ATTENDED PLAN SHOWING ADDITION OF EXTRA BAY TO NORTH WING.

WELLINGTON CENTRAL LIBRARY.

DRAWING NO. O.

NOTE: AN ADDITIONAL BAY IS TO BE INTRODUCED IN THE LENGTH OF THIS NORTH WING AS INDICATED ON THE AMENDED PLAN DRAWING NO. O.
THIS WILL BE A COMPLETE MODIFICATION OF THE BAY INCLUDED WITHIN THE RECTANGLE A B C D.

**FIRST FLOOR
FRAMING PLAN.**

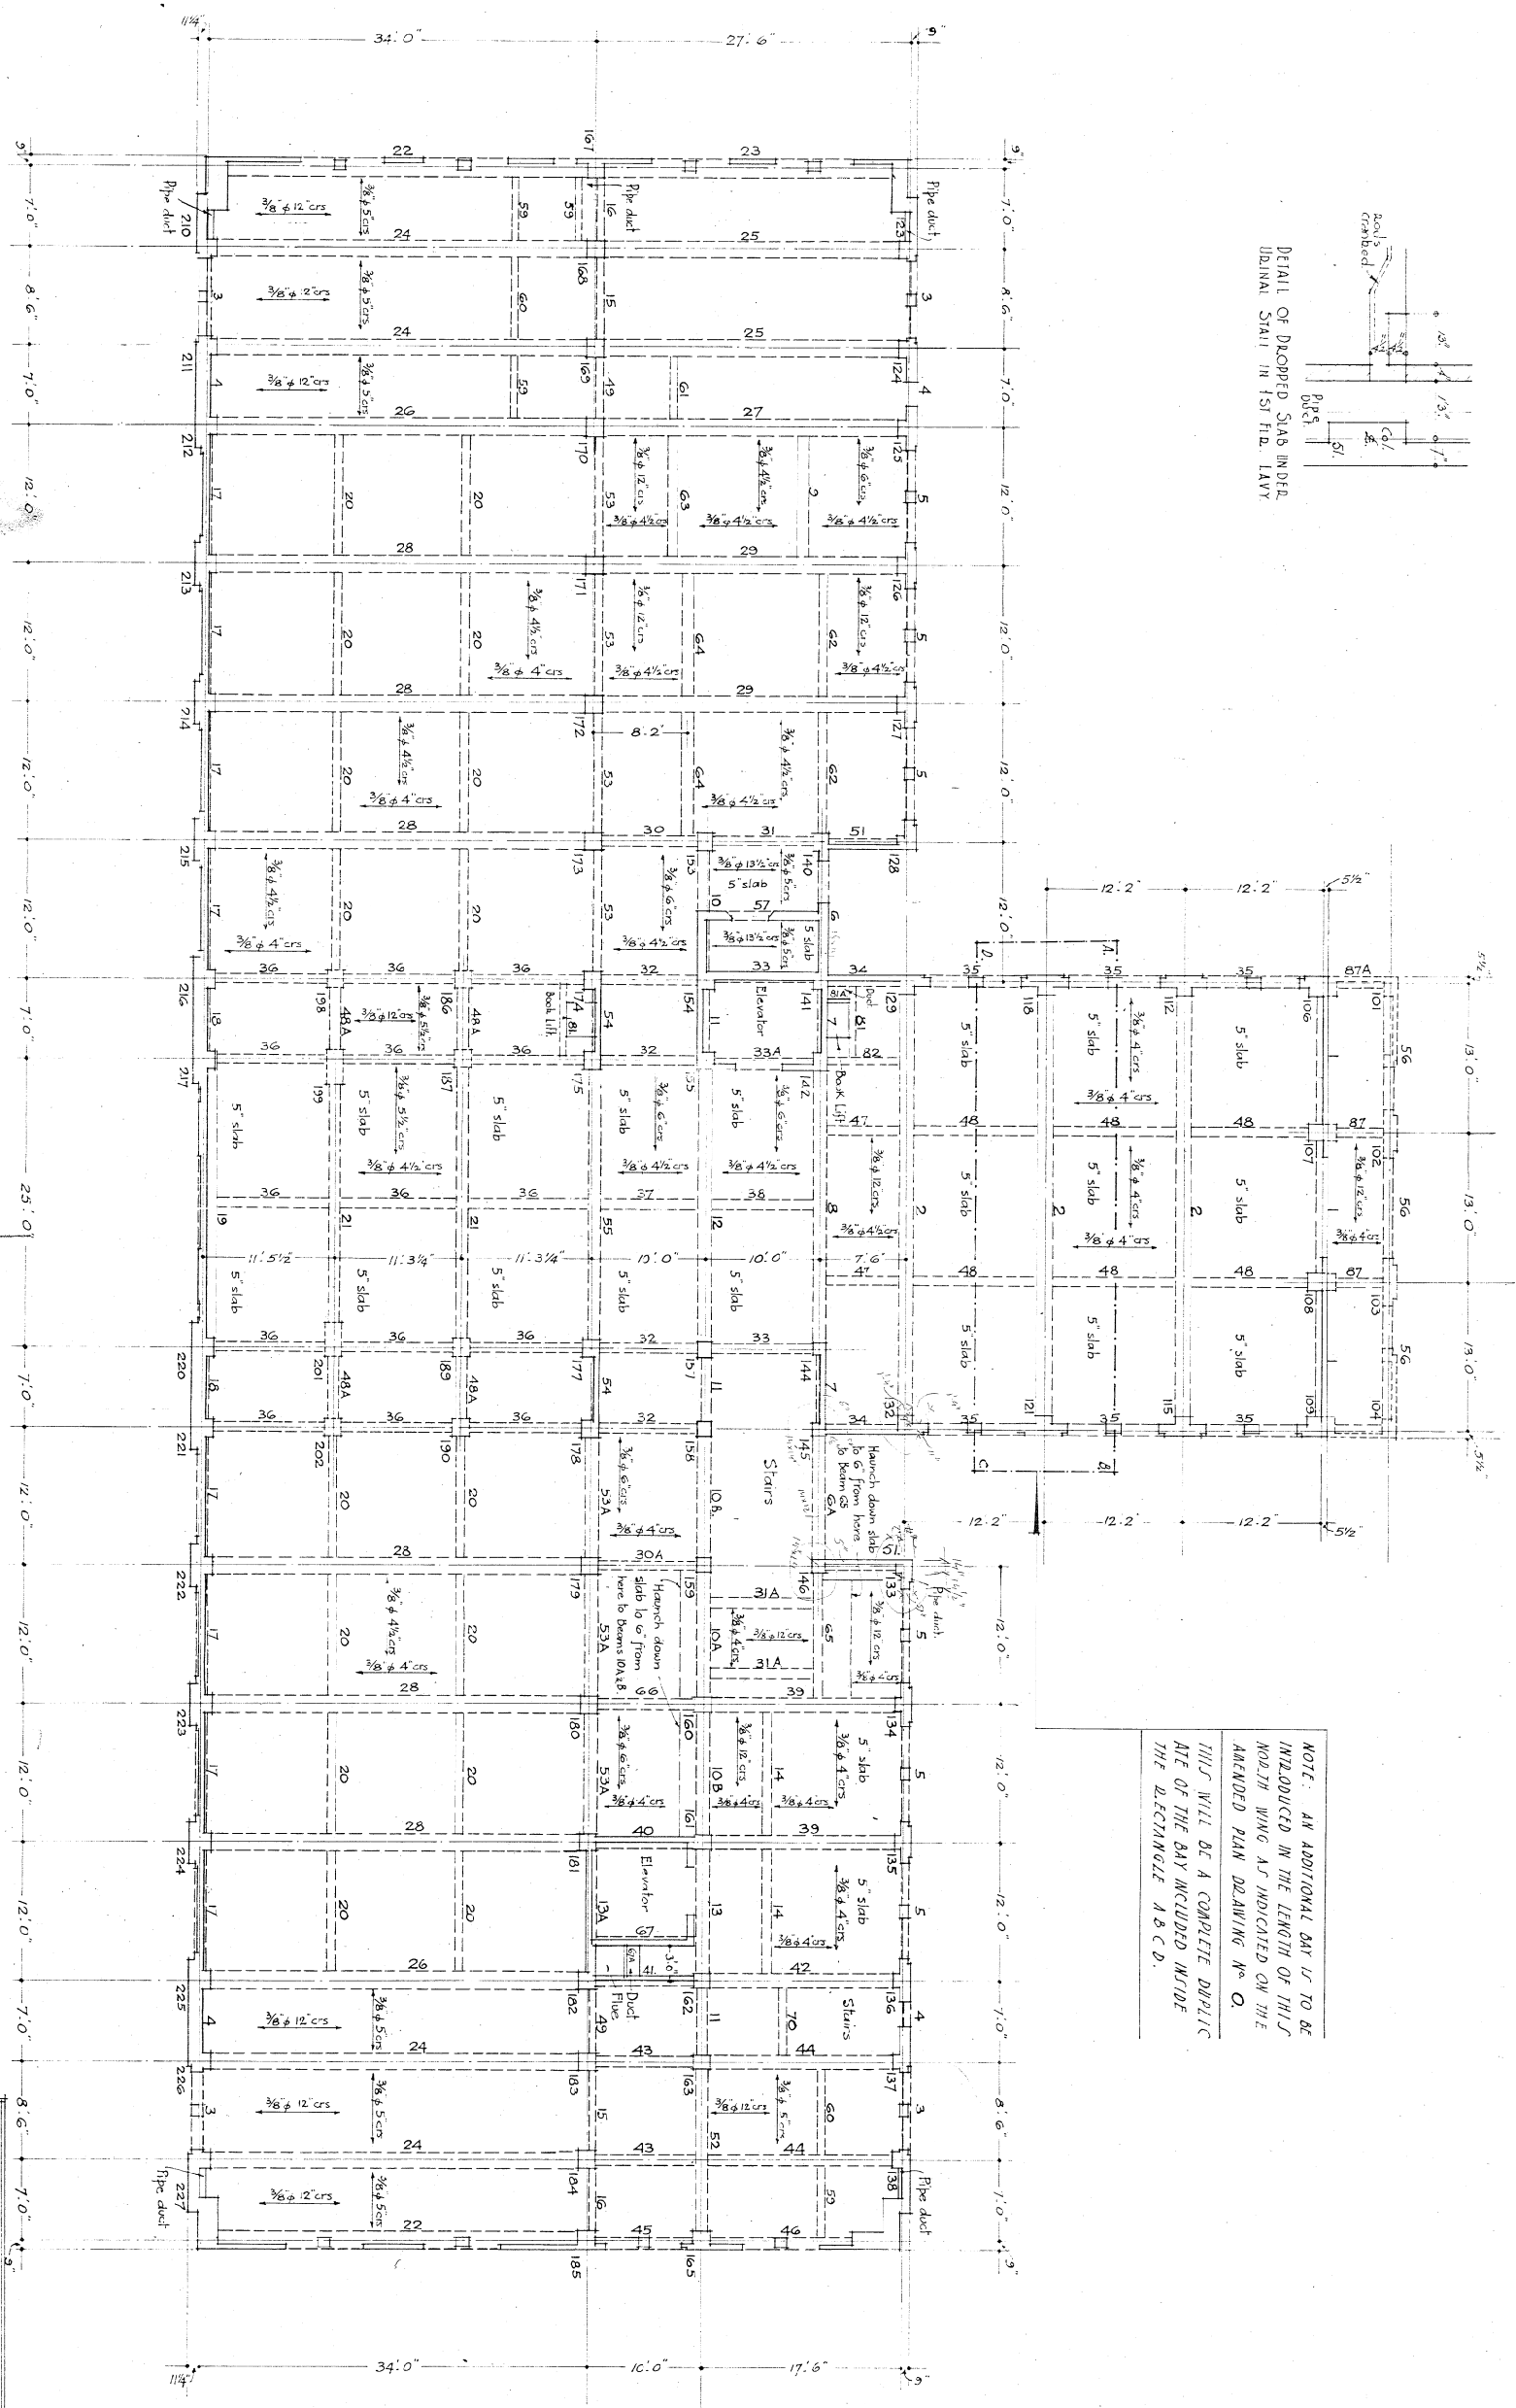
NOTE: AN ADDITIONAL BAY IS TO BE
INTRODUCED IN THE LENGTH OF THIS
NORTH WING AS INDICATED ON THE
AMENDED PLAN DRAWING NO. O.
THIS WILL BE A COMPLETE DUPLICATE
OF THE BAY INCLUDED INSIDE
THE RECTANGLE A B C D.
